# RESPONSE TO SUBMISSIONS AND PRELIMINARY ASSESSMENT

SCEGGS DARLINGHURST CONCEPT PLAN  
AND WILKINSON HOUSE REDEVELOPMENT

SA7240  
FINAL  
PREPARED FOR SCEGGS DARLINGHURST

Figure 1 – Proposed Amendments to Wilkinson house

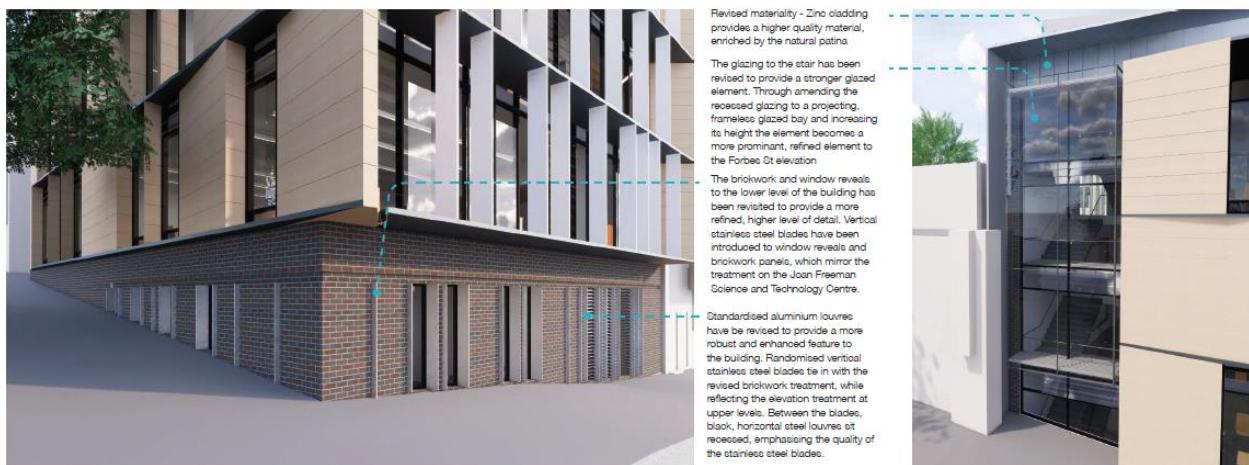
The proposed design amendments to the submitted new Wilkinson House create a more refined, highly detailed building, improving the pedestrian experience (see **Figure 1**). Improvements are also being made to the materials at the top of the building and to the glazing to the stair.

At the ground level, the brickwork and window reveals have been refined and improved. Stainless steel vertical blades have been introduced to mirror the treatment on the Joan Freeman Science and Technology Centre. They are designed to tie in with the revised brickwork treatment while reflecting the vertical elements on the upper levels.

The cladding at the top of the building has been changed to Zinc, providing a higher quality material, that will gain a natural patina over time.

The glazing of the stair has been revised to be a projecting, frameless glazed bay and increasing the height of the element to create a more prominent, refined streetscape element on the Forbes Street elevation.

Figure 2 – Proposed Amendments to Administration Building

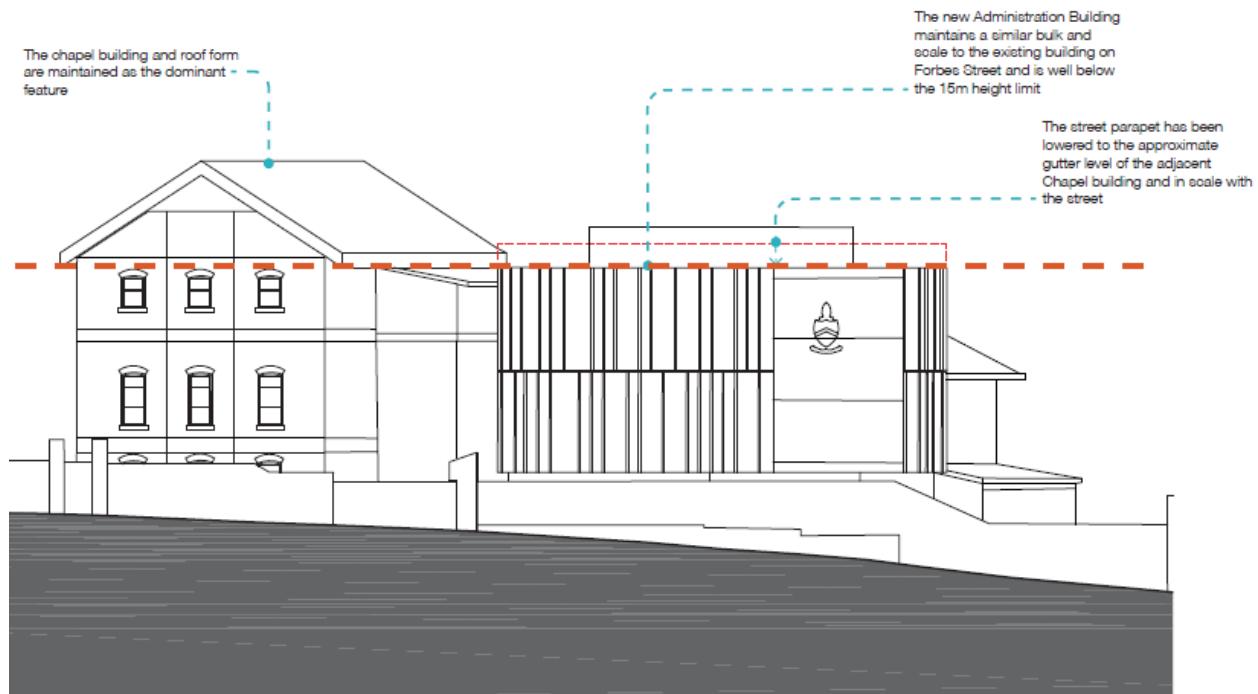
The building envelope of the new Administration Building has been revised to reduce the height of the street parapet (**Figure 2**). The street parapet has been lowered to the approximate gutter level of the adjacent Chapel Building. This creates an improved relationship between the two buildings without the loss of functional floorspace.

The reduced height establishes the Chapel Building as being more dominant and improves the appearance of the overall streetscape.

Figure 4 – Proposed Building Envelope Amendments to the Multi-purpose building

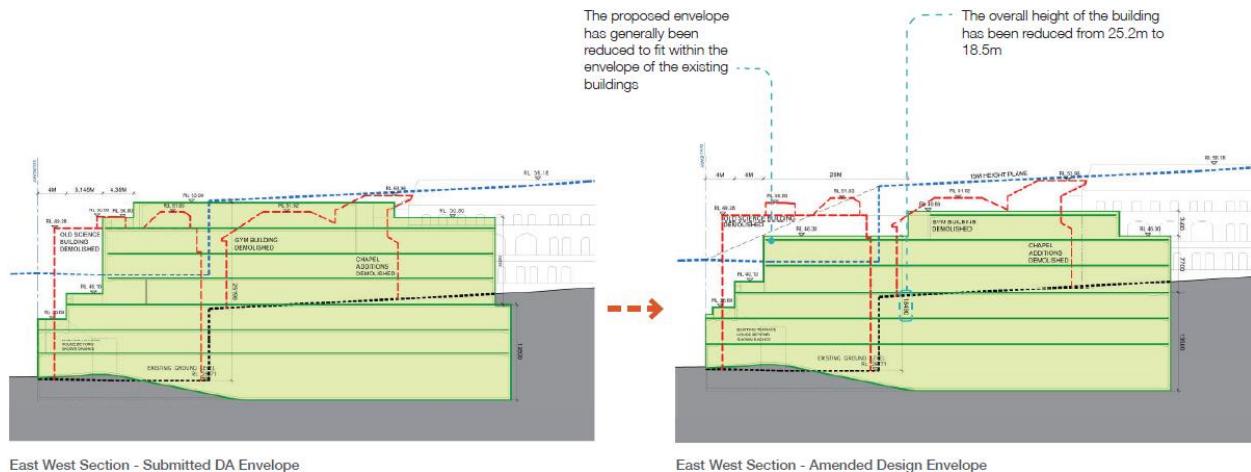
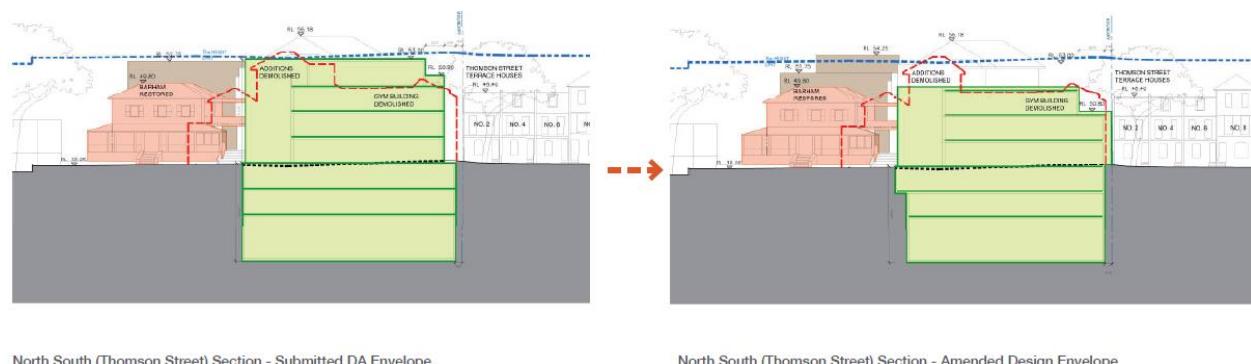
In response to the submissions received, significant design changes are proposed for the multi-purpose building envelope. Generally, the built form issues raised in the public submissions related to where the proposed building envelope exceeded the existing built form on the site.

The proposed building envelope has been reduced to be generally within the envelope of the existing buildings so that there are minimal, if any, additional impacts to neighbouring properties. The overall height has been reduced from 25.2m to 18.5m.

- The envelope has been aligned parallel to the street in keeping with the existing alignment of existing neighbouring buildings.
    - Deletion of the blade wall adjacent to the Bourke Street Terraces in order to improve the streetscape and the relationship with existing adjoining buildings.

Figure 6 - Amended 3D Height Plan

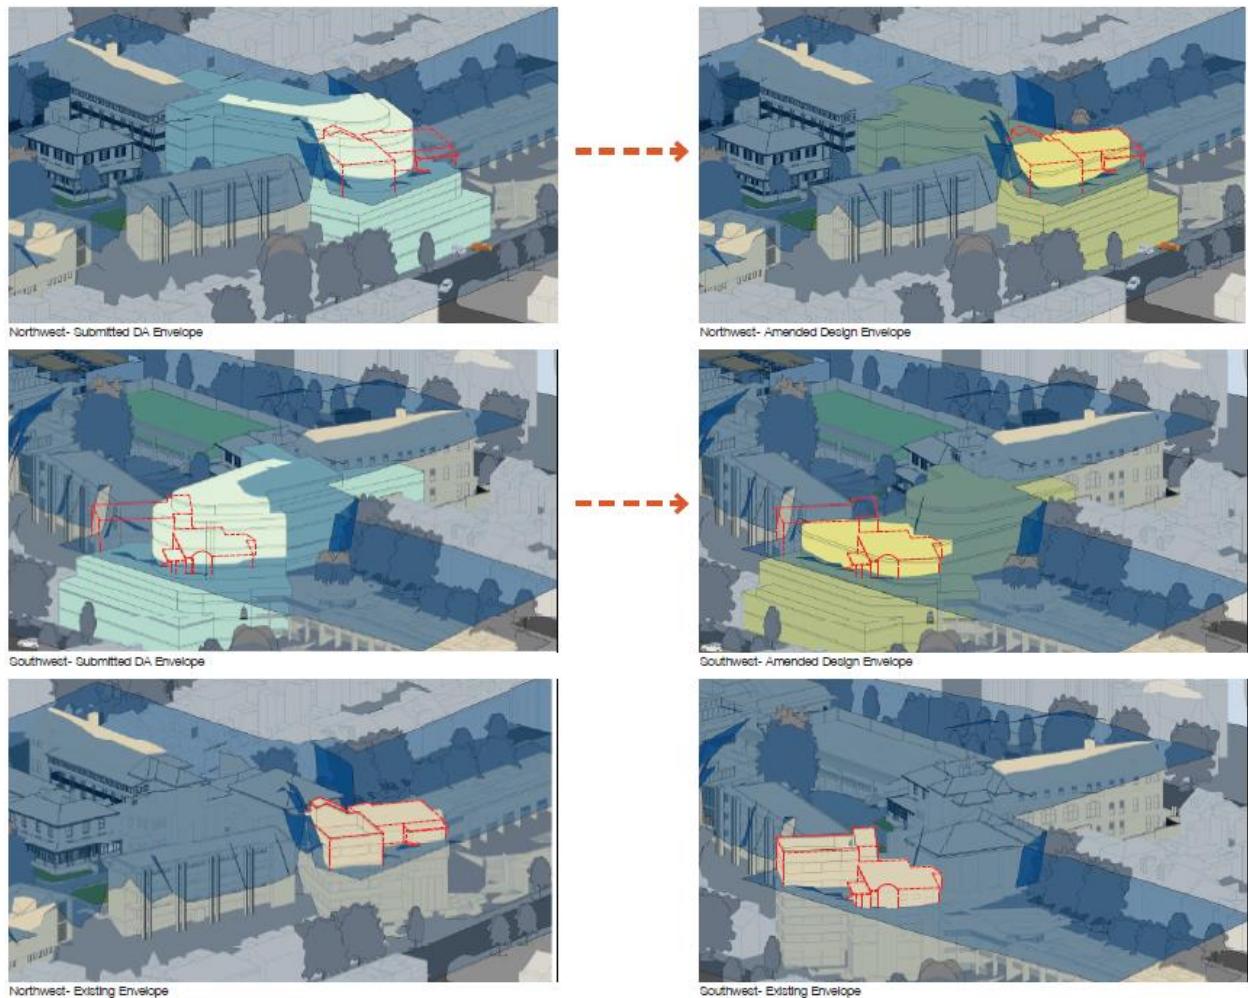
In response to a request made by the DPIE, a 3D height plan diagram including an outline of the existing buildings over the proposed building height is provided below (**Figure 6**) and within the architectural package at **Appendix C**. As shown within **Figure 5**, the scale of the development fronting Bourke Street has been significantly reduced and is generally contained within the existing building envelopes. The proposed orientation of the revised building however directly addresses the alignment and frontage to Bourke Street compared to the existing buildings, resulting in a more appropriate and contextual streetscape presentation.

In response to submissions the maximum building height has been reduced in the amended design from 25.2m to 18.5m. The Bourke Street frontage will also be reduced from 7-storeys to 5-storeys with a stepped form. The two-storey podium form will be maintained in line with the adjacent terraces before stepping back twice to the upper levels.

Figure 10 – Thomson Street Winter Solstice Overshadowing Impacts

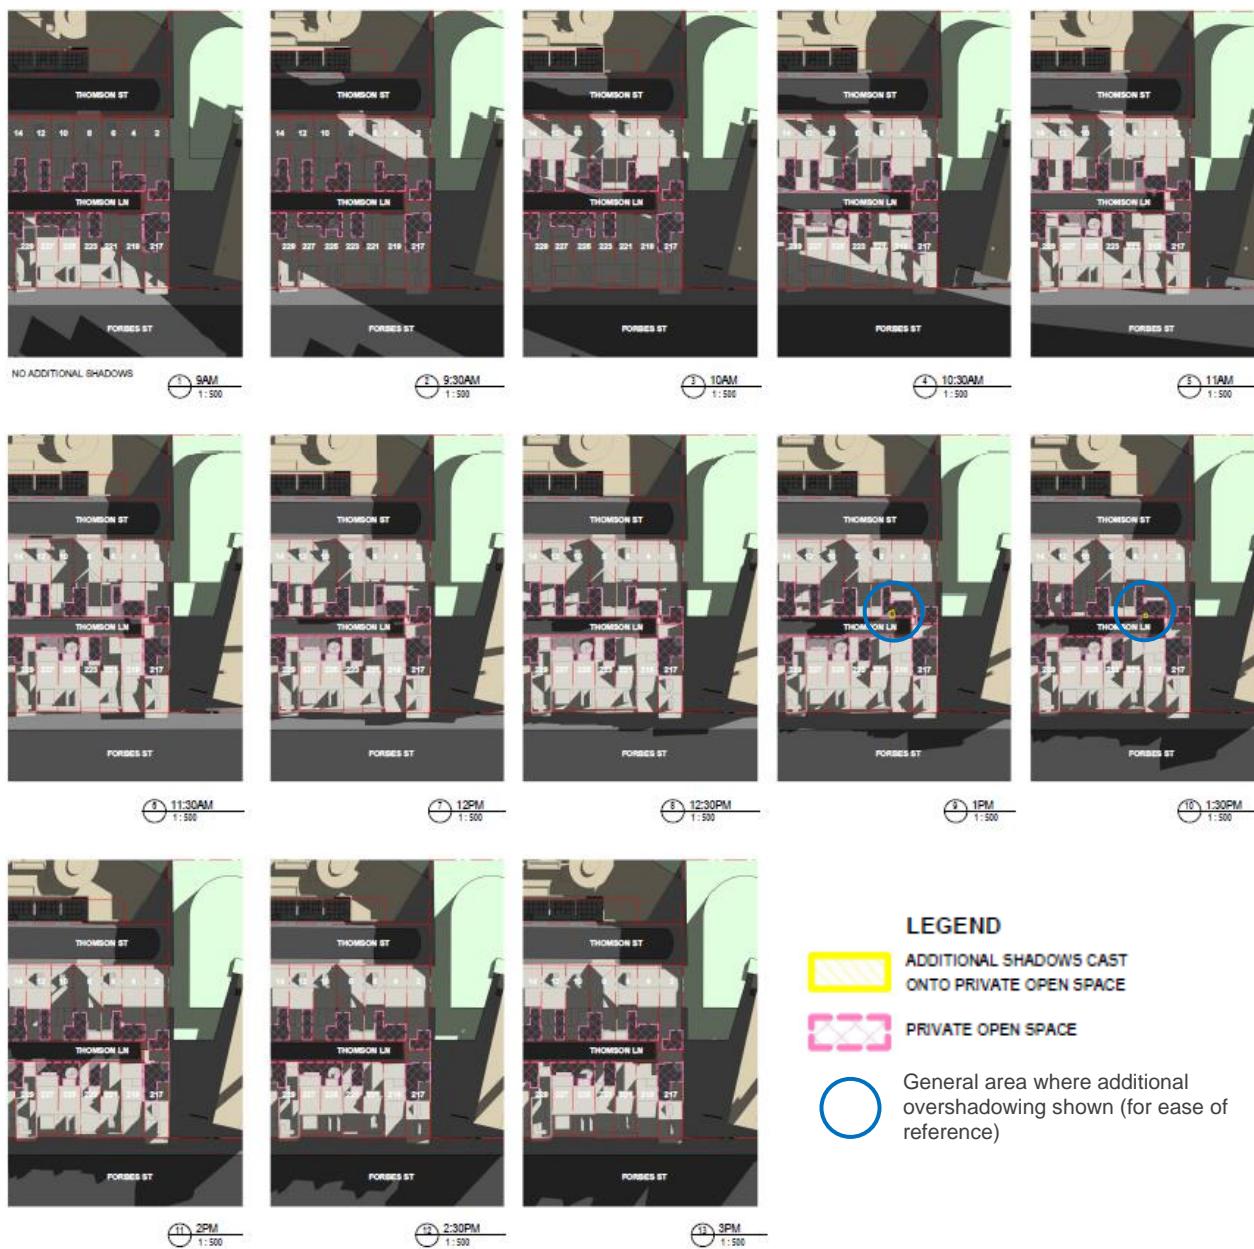
**Figure 10** shows that at 21 June, only 4 Thomson Street will have additional shadows cast into the rear private open space, at the small south east corner at 1:00pm and 1:30pm, as a result of the proposed multi-purpose building envelope. This negligible additional overshadowing to the rear corner for 30 minutes in mid-winter is unlikely to have a observable impact on the overall amenity of the dwelling. Furthermore, this additional overshadowing is resultant from Level 6 of the multipurpose building, which is proposed within the 15m maximum height plane control and therefore is considered an appropriate impact.

Figure 11 – Amended Overshadowing Impacts upon Thomson Street

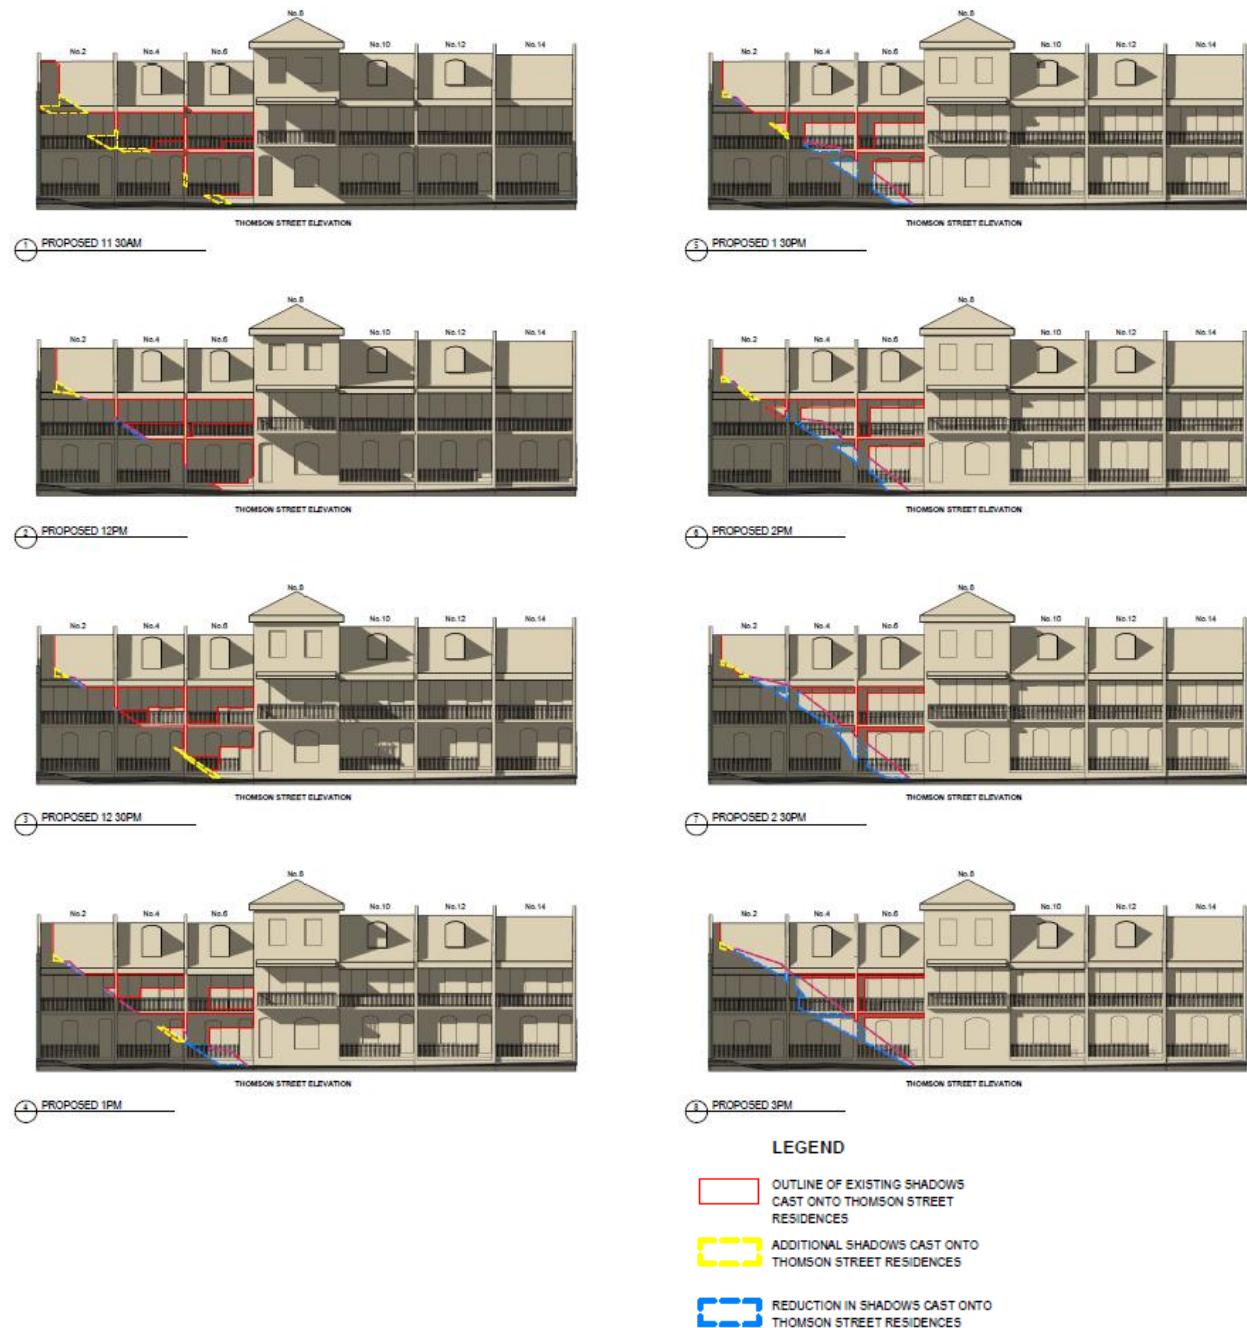
**Figure 11** shows the overshadowing impacts of the revised design upon the front facades of the Thomson Street residences. The shadow study shown here is during the winter solstice on the 21 June. Thomson Street residences are in full shadow until 11.30am as the sun is behind the façade. As a result of the revised building envelope, the net extent of shadows on the front elevations of 2 – 6 Thomson Street is reduced, when compared to the existing buildings. As such there is a net improvement to the solar access of the façade to the Thomson Street terraces, most significantly to 4 and 6 Thomson Street, as a result of the proposed development.

The shadows outlined in yellow show the additional shadow cast by the proposed development. The areas outlined in blue show where the existing shadows have been reduced based upon the amended building envelope, resulting in an improved solar outcome for the 4 and 6 Thomson Street neighbours.

Figure 12 – Amended Design Bourke Street Overshadowing Impacts

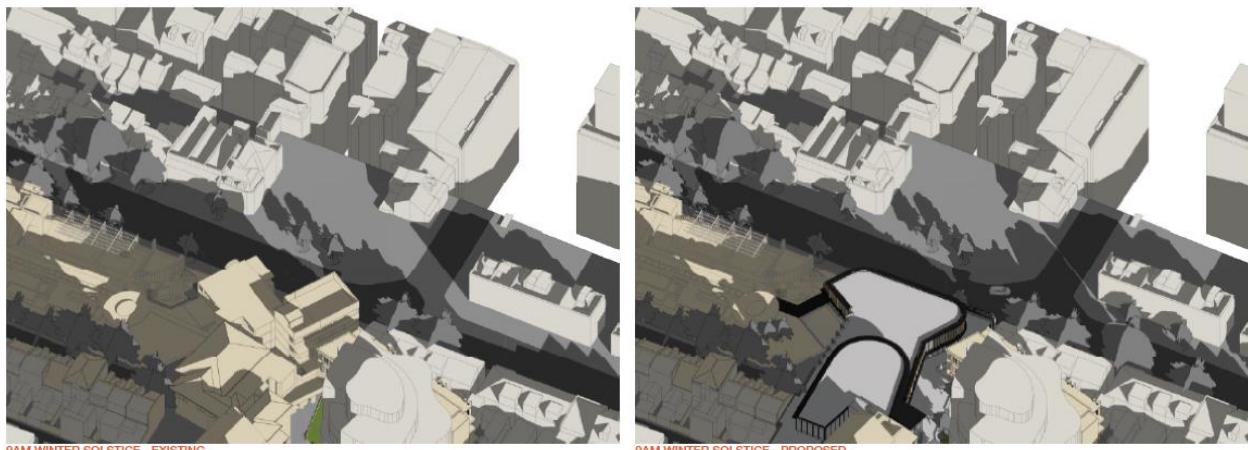
One submission raised concerns over the impacts of overshadowing to the dwellings on Bourke Street to the west of the site. **Figure 12** below shows that the amended multi-purpose building design will have a decreased shadow impact to Bourke Street when compared to the existing buildings.

The shadows will not extend onto the Bourke Street façade of 7 O'Brien's Lane from 9:00am, resulting in a positive outcome for residents.

Figure 16 – Proposed Variation to the Height of Building Standard – Wilkinson House

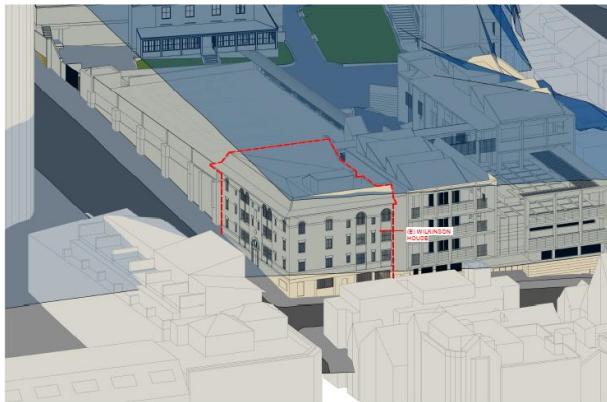
The proposed Wilkinson House building will also exceed the 15m height of building standard at this location as shown in **Figure 16** The maximum height exceedance proposed for the proposed Wilkinson House building is 1.42m.

A Clause 4.6 variation request has been prepared to accompany this application at **Appendix G**.

Figure 17 – Proposed East West Section – Proposed Multi-Purpose Building

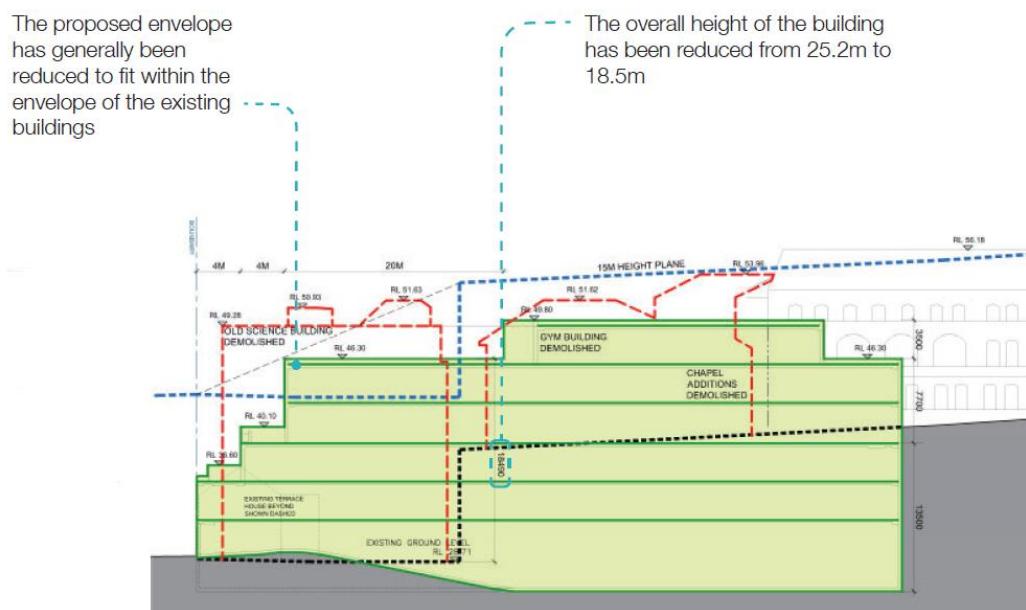
The amended multi-purpose building will exceed the maximum height of building standard by 2.49m at the Bourke Street frontage. As illustrated at **Figure 17**, this height exceedance is less than the existing buildings fronting Bourke Street. As the site rises to the east, the building is significantly below the height limit and is lower than the height of the existing buildings.

The form above the maximum building height limit does not negatively affect views, privacy or overshadowing compared with the existing buildings as explored in **Section 5.3**. A clause 4.6 variation request has been prepared to accompany this application at **Appendix G**.
